Access Compliance Report

Public Rights-of-Way

Intersection ID: 22500	Main Street: CHADMORE_SOUTH_DR	Cross Street: HARRISONWOODS_PL	Location: W
ADA ID: 7E572E32E469	Ramp Type: PerpDiag	Initial Pass/Fail: Fail	Overall Compliance: No
		Severity Score: 25

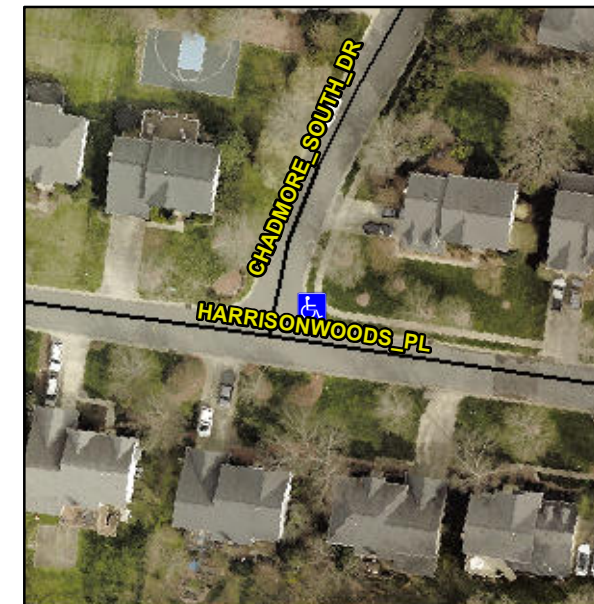
Not Found, R304.2.2, R304.5.3

Compliance	Description	Data	Compliance	Description	Data
N/A	Ramp Length (in)	45.5	No	Ramp Slope (%)	9.3
Yes	Ramp Width (in)	48.0	No	Ramp XSlope (%)	6.2
N/A	Flare Type LT	N/A	N/A	Flare Type RT	N/A
N/A	Flare Slope LT (%)	N/A	N/A	Flare Slope RT (%)	N/A
N/A	Flare Traversable LT?	N/A	N/A	Flare Traversable RT?	N/A
N/A	Landing Length (in)	N/A	N/A	DWS Provided?	N/A
N/A	Landing Width (in)	N/A	N/A	DWS Contrast?	N/A
N/A	Landing Slope (%)	N/A	N/A	DWS Length (in)	N/A
N/A	Landing X Slope (%)	N/A	N/A	DWS Full Width?	N/A
N/A	Landing Curb? (Y/N)	N/A	N/A	DWS Offset (in)	N/A
N/A	Shared Landing?	N/A			
N/A	Gutter Ponding?	N/A	N/A	Gutter Slope (%)	N/A
N/A	Gutter Lip Ht (in)	N/A	N/A	Gutter X Slope (%)	N/A
N/A	Painted X Walk1?	No	N/A	Painted X Walk2?	No
	X Walk 1 Direction	To NE		X Walk 2 Direction	To SW
N/A	X Walk 1 Width (in)	N/A	N/A	X Walk 2 Width (in)	N/A
	X Walk 1 Slope (%)	5.6		X Walk 2 Slope (%)	1.1
	X Walk 1 X Slope (%)	0.7		X Walk 2 X Slope (%)	4.1

Remove & Replace Curb Ramp With Two New Directional Ramps or Equivalent.
